DATE: 02.12.2019

Traffic Engineering

■ WOODLANDS AT ECHO FARMS TRACT 3A [TRC Plan Review #2]

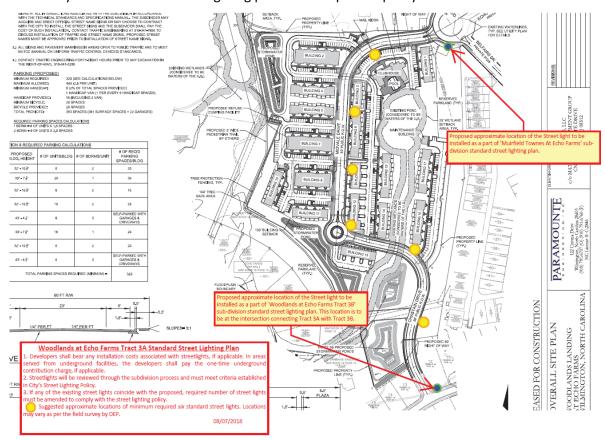
Show and apply the City's 20'x70' sight distance triangle at the driveway off Chastian Dr roundabout.
